Fargo VAMC – Refurbish Elevators and Replace Controls

Fargo, North Dakota
Project #19-2481

MARCH 26, 2024

ADDENDUM NO. 2

Drawing Number
A5.30

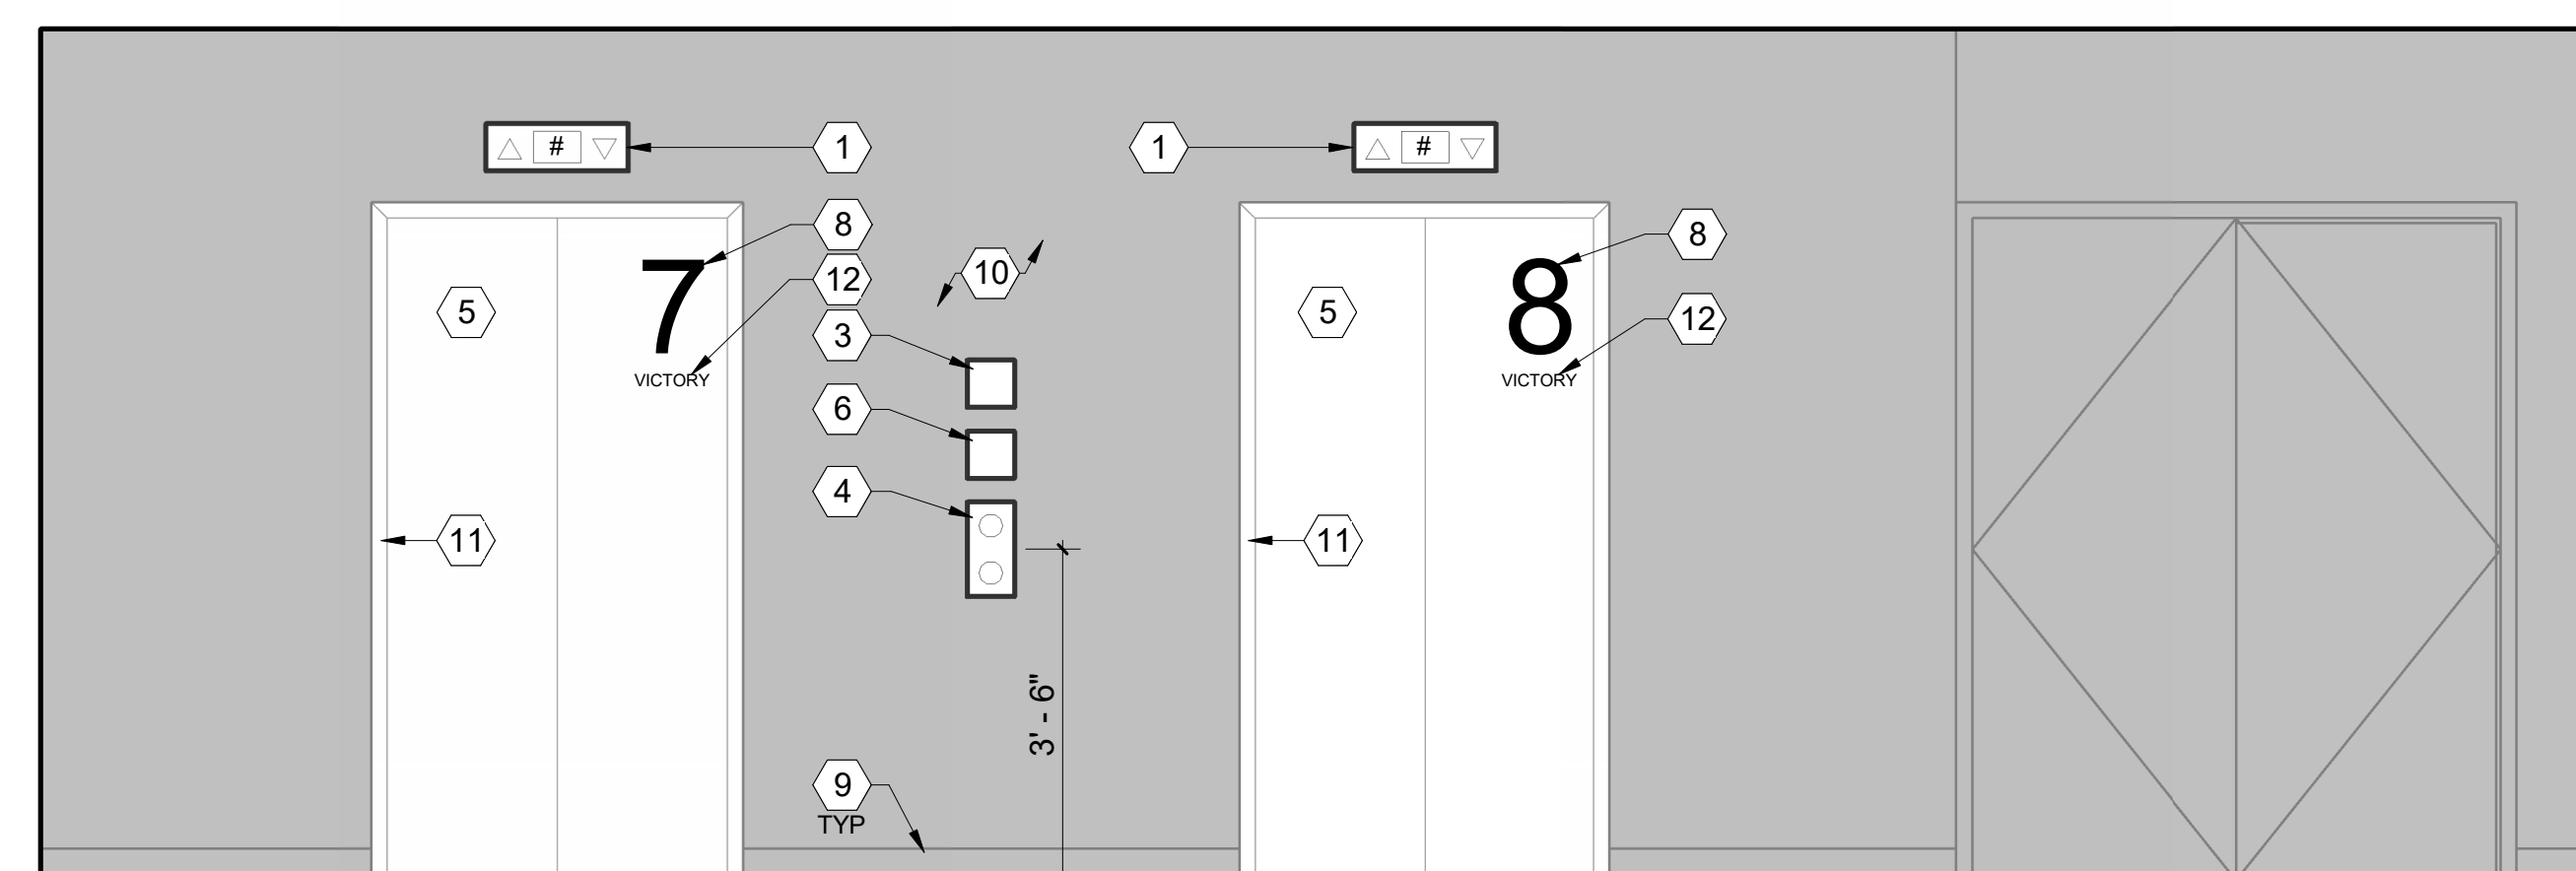
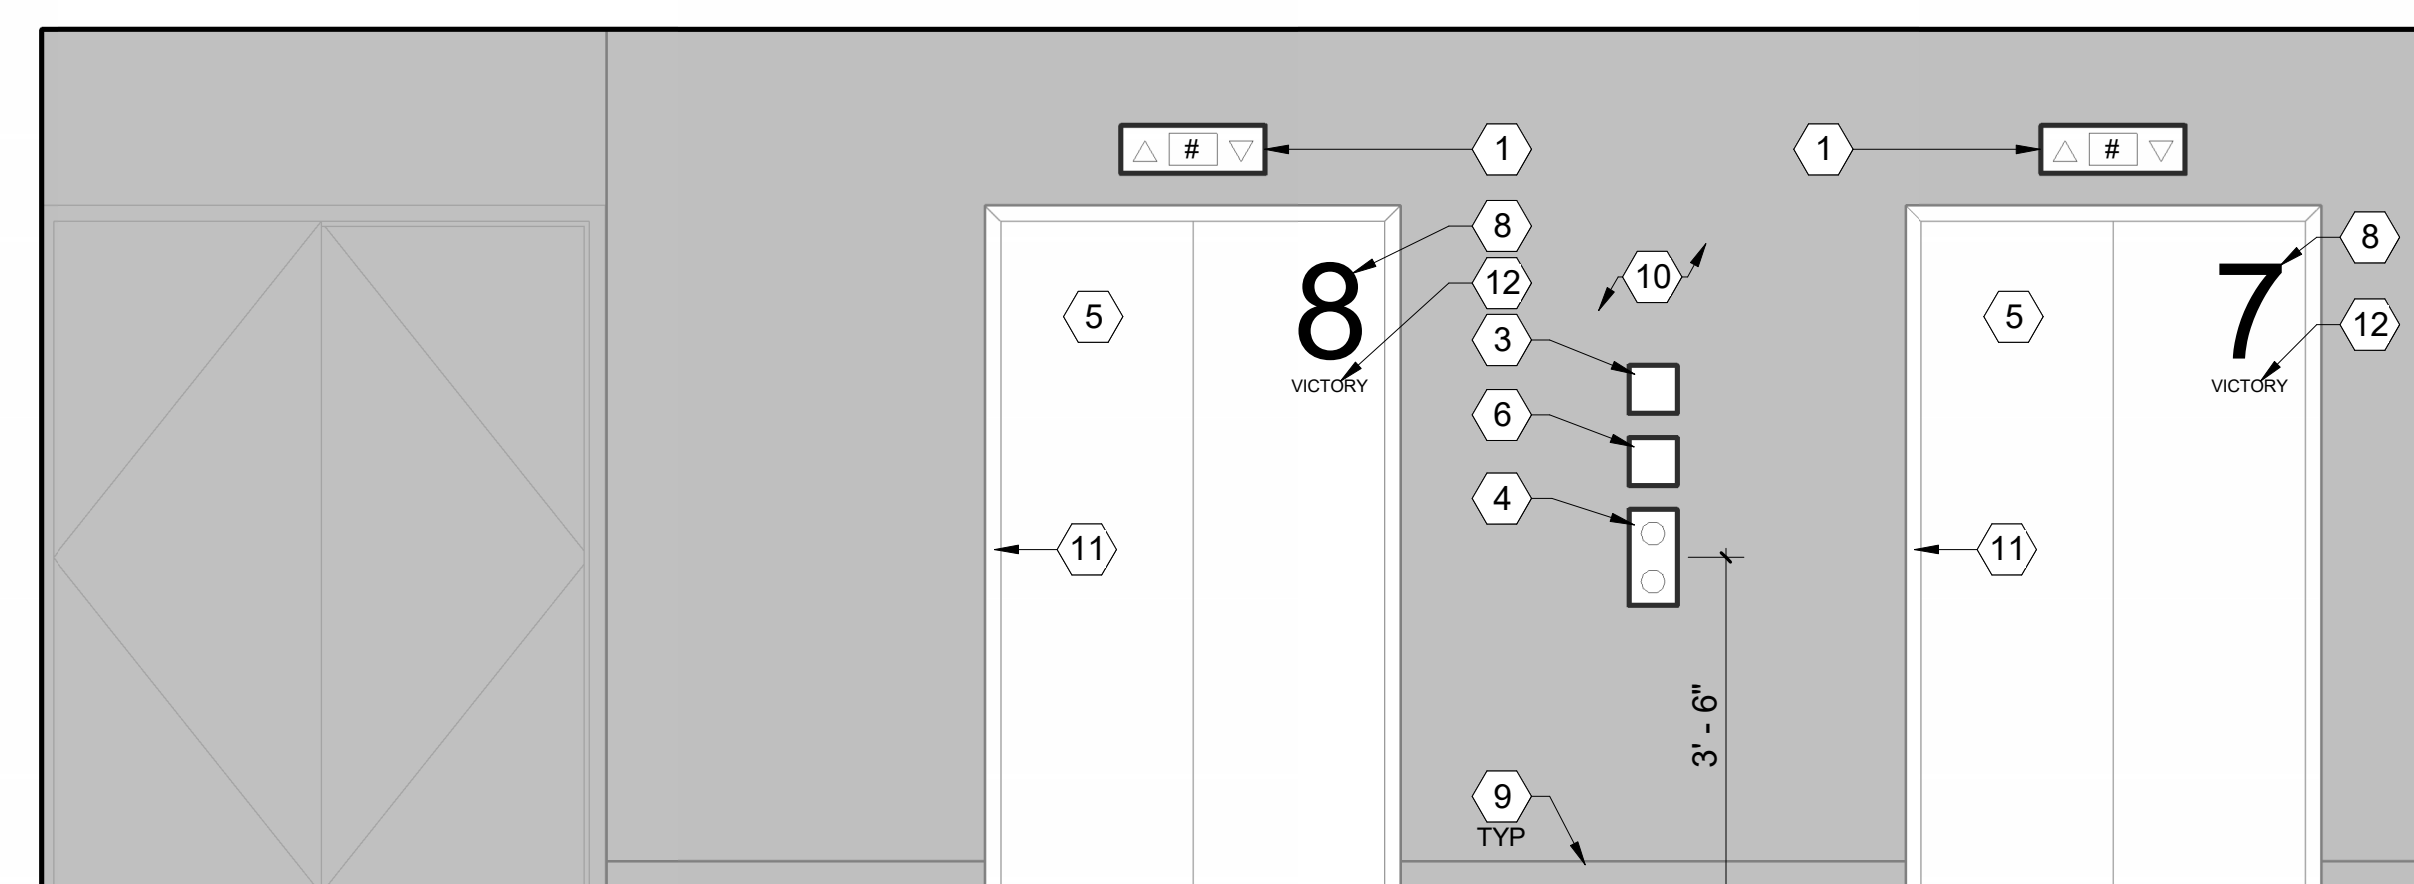
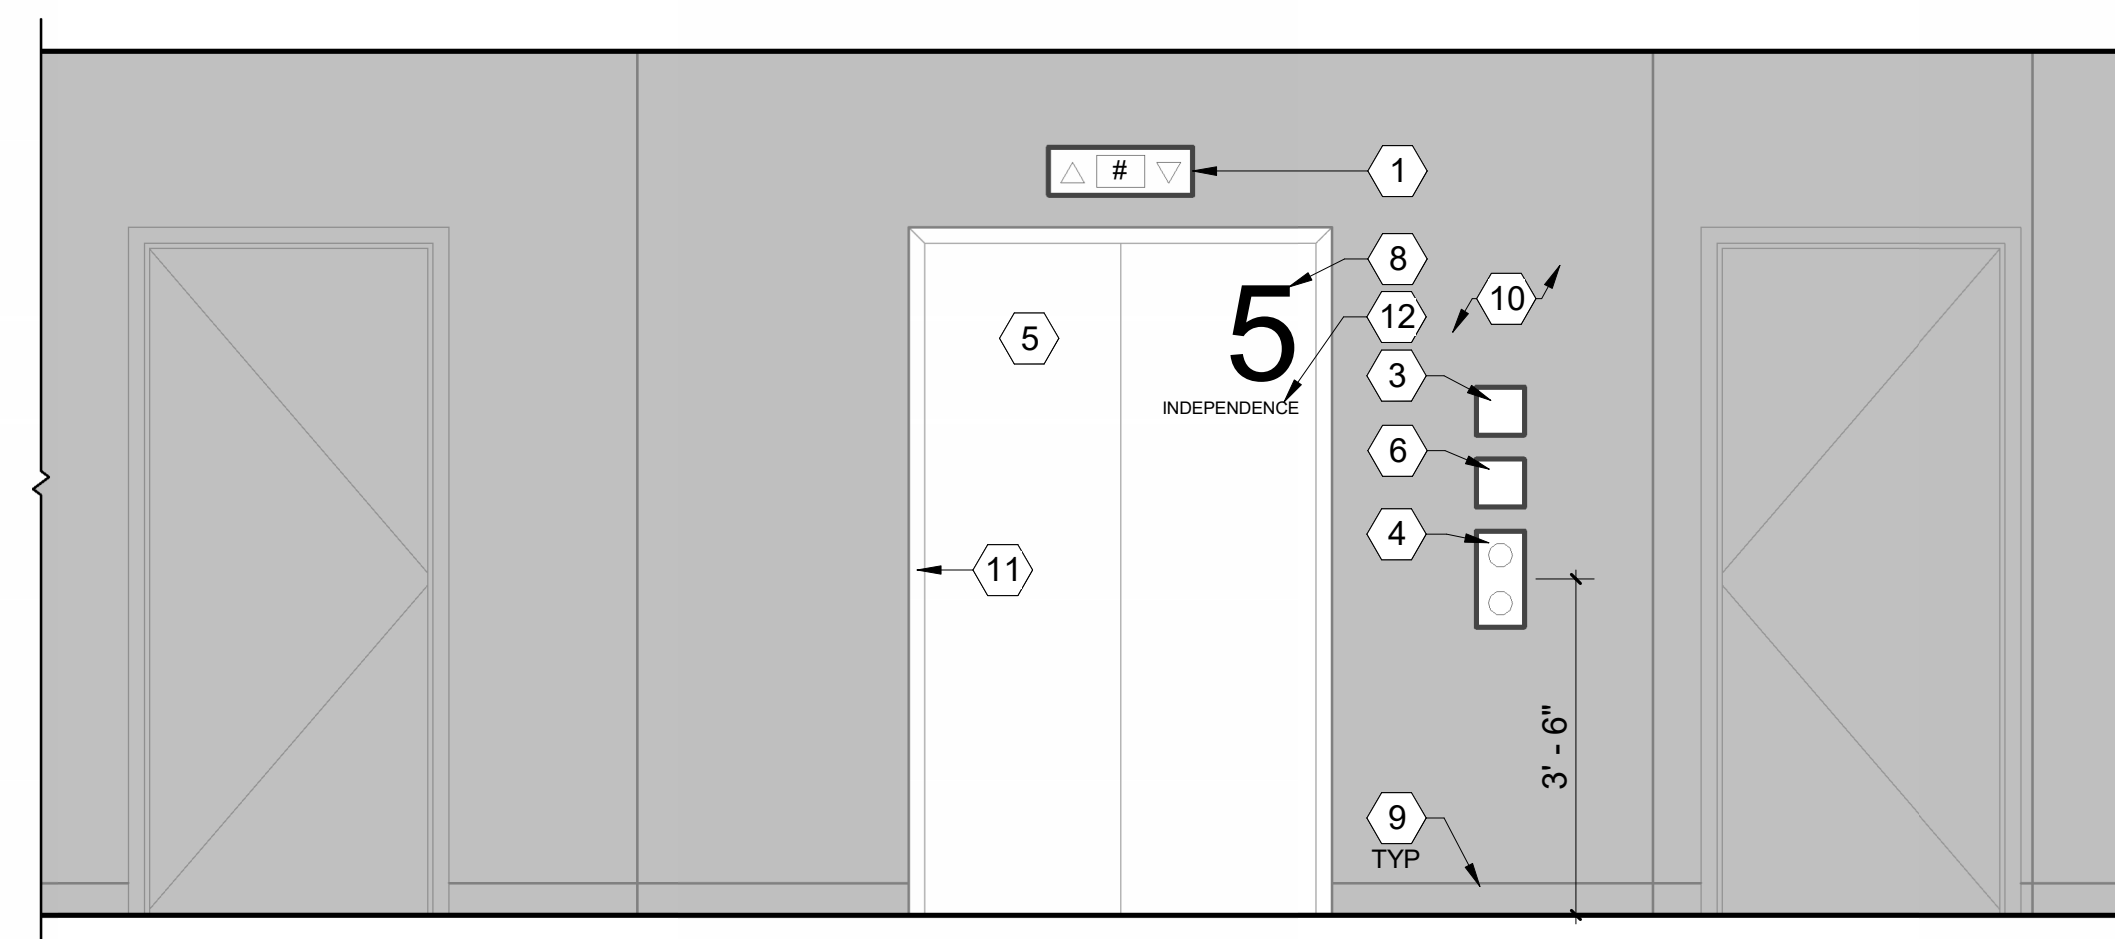
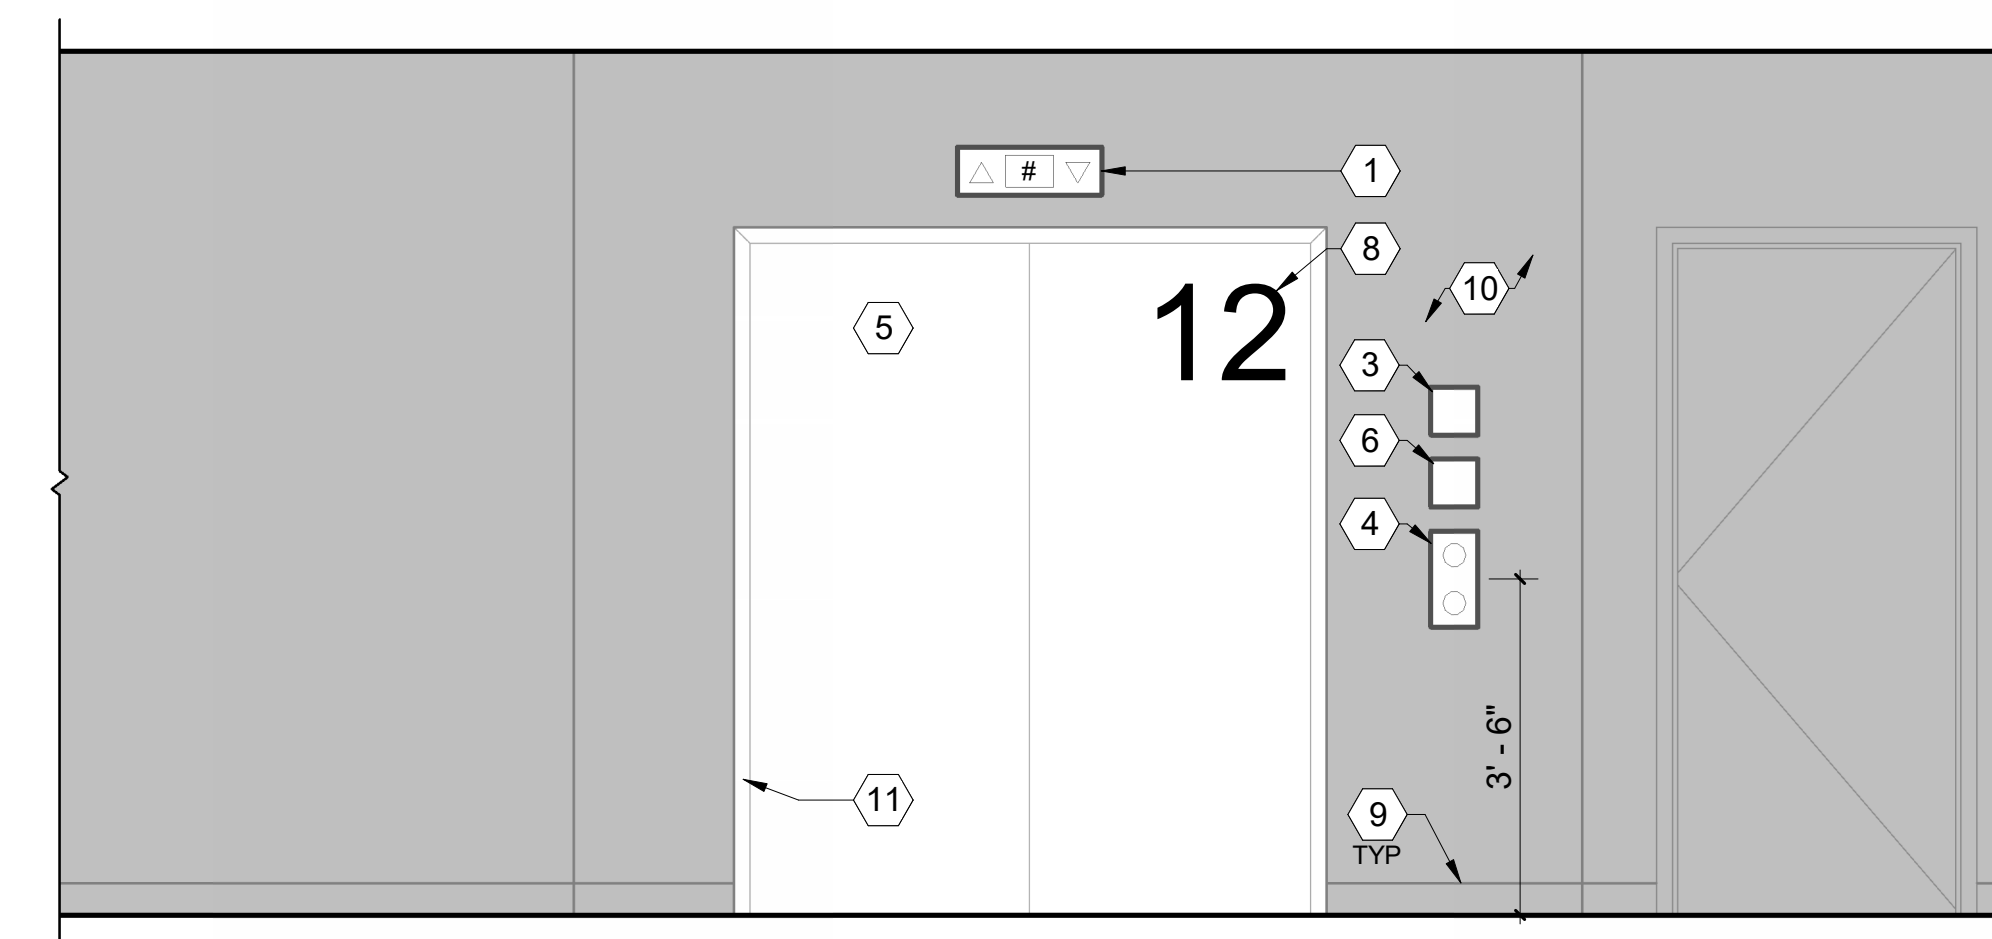
Drawing Sheet A5.30 INTERIOR ELEVATIONS - LOBBIES – See revised drawing sheet for the adjustment of keynotes # 11.

9. EXISTING WALL BASE TO REMAIN, TYPICAL.
10. PATCH, REPAIR AND FINISH ALL EXISTING WALLS AS REQUIRED FOR REPLACEMENT OF ALL CONTROLS AND INDICATORS.
11. RECLAD EXISTING STAINLESS STEEL HOISTWAY ENTRANCE JAMBS.
